CHISHOLM CREEK 2ND ADDITION WICHITA, SEDGWICK COUNTY, KANSAS

RE: S/D 00-13 -- Final Plat of CHISHOLM CREEK 2ND ADDITION

STAFF COMMENTS:

CASE NUMBER: S/D 00-13 -- CHISHOLM CREEK 2ND ADDITION

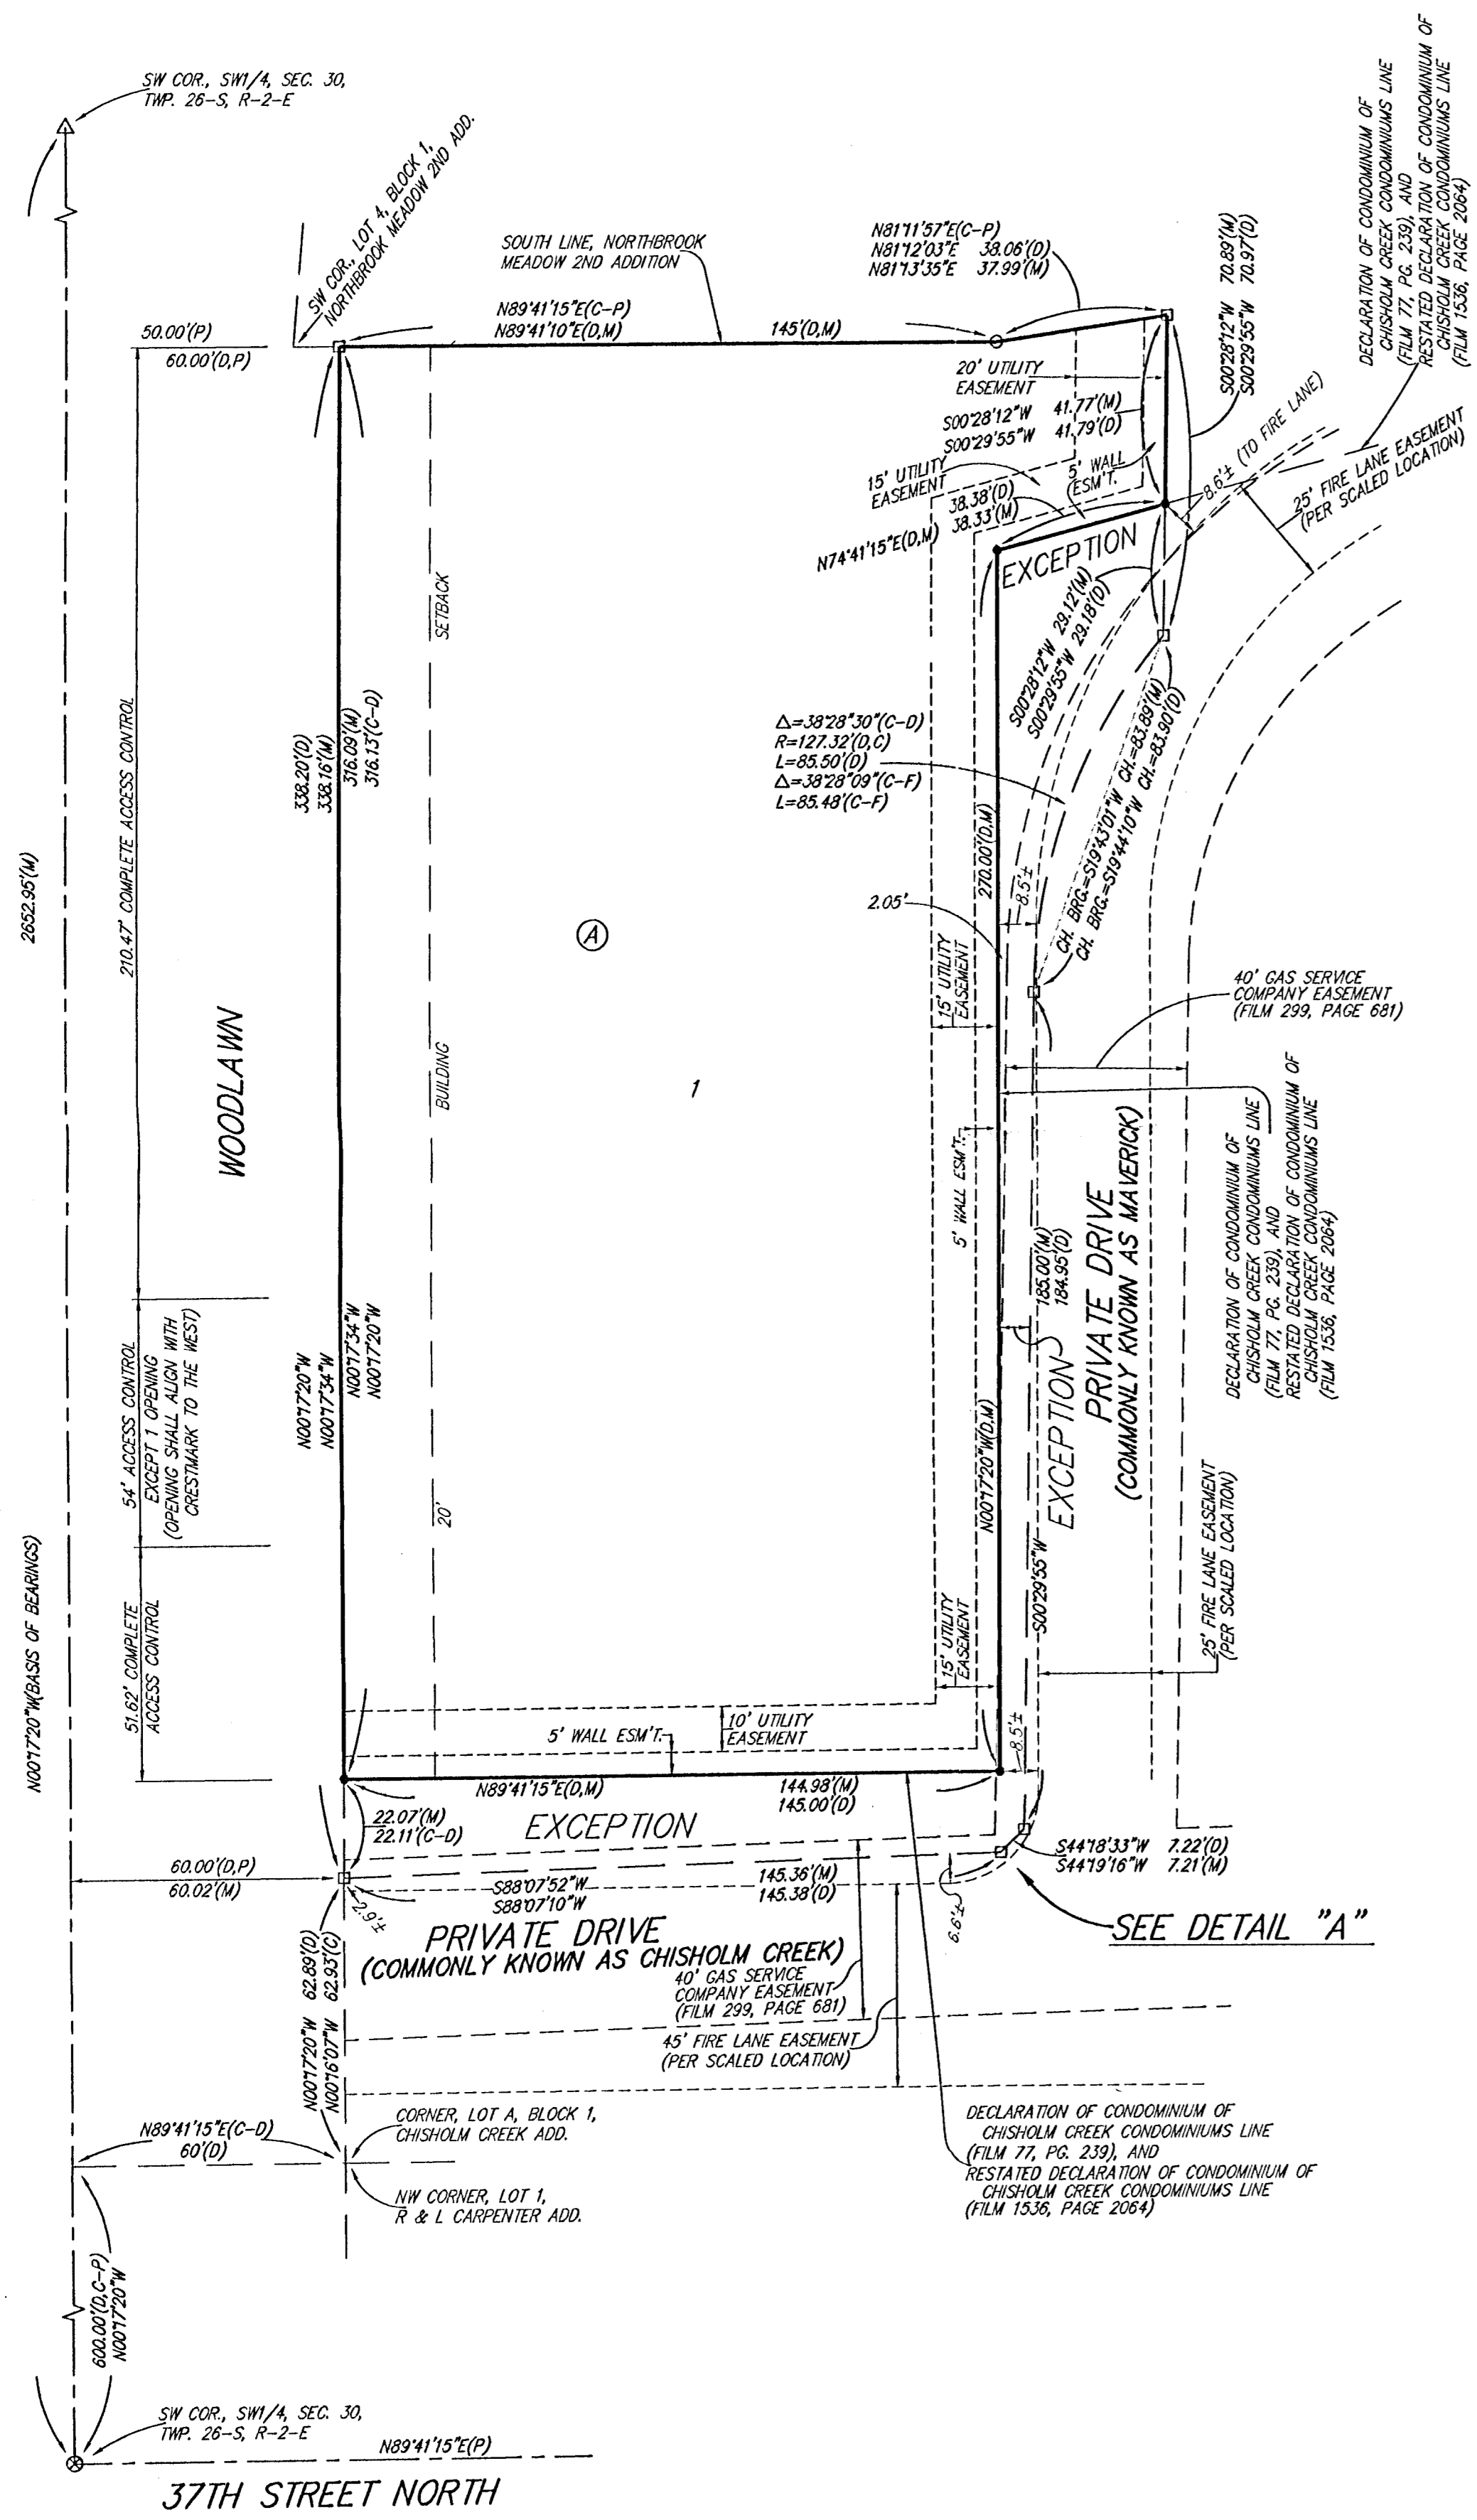
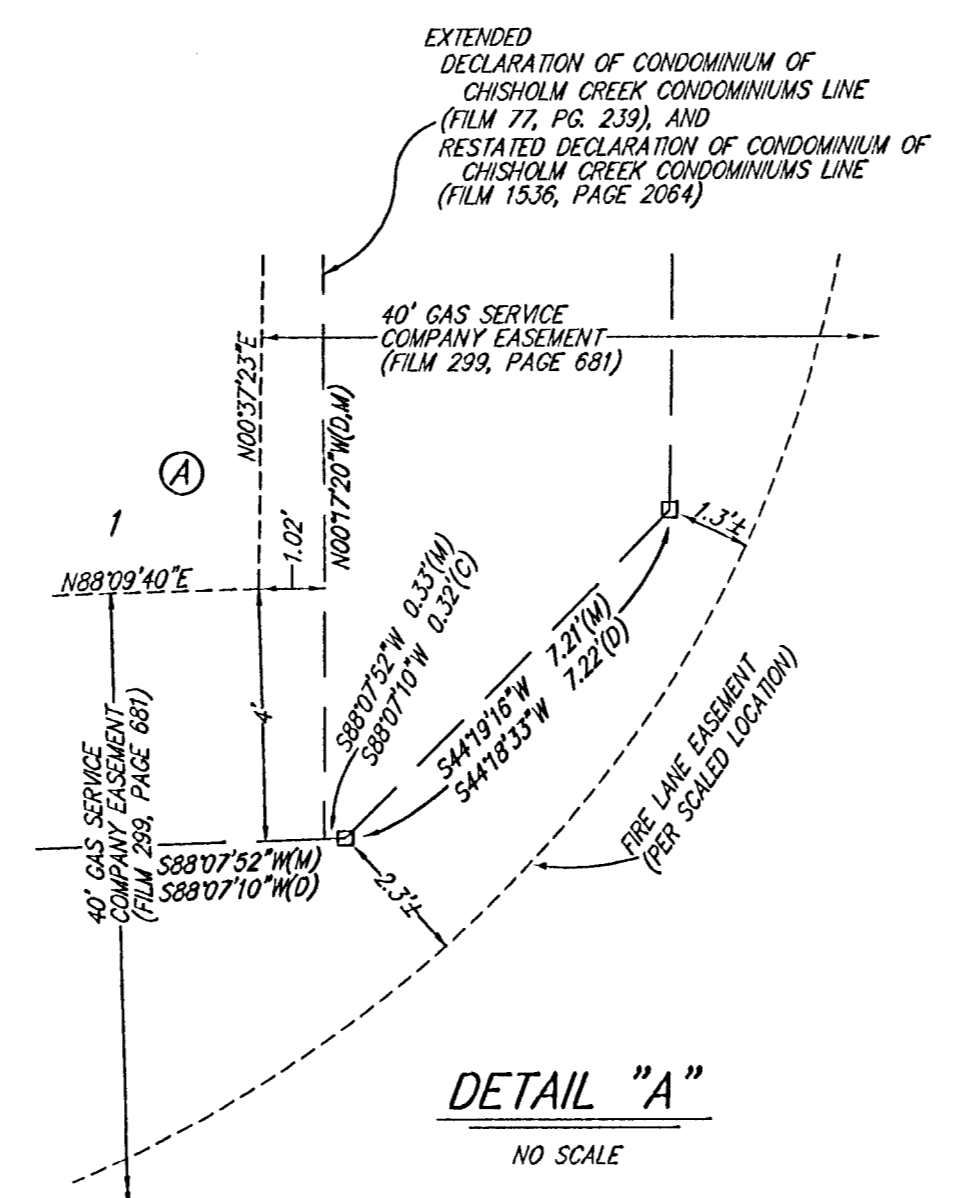
- E. The described distance and bearing for the southeastern property line as referenced in the legal description of the plat's text needs to be included on the face of the plat.

- F. It is recommended that the utility easements be set back from the south and east property lines appropriately to protect existing tree rows.

- H. The Fire Lane easement and the Declaration of Condominium Line needs sufficient ties to locate it definitely with respect to the subdivision.
- I. The following note needs to be removed under the Bench Mark: "Note: Minimum building pad elevation requirements will be established on the final plat."

- J. The plattor's text shall include language that a drainage plan has been developed for the plat and that all drainage easements, rights-of-way, or reserves shall remain at established grades or as modified with the approval of the applicable City or County Engineer, and unobstructed to allow for the conveyance of stormwater.

As requested, the Applicant has increased the utility easements to 20 feet along the east and south property lines.
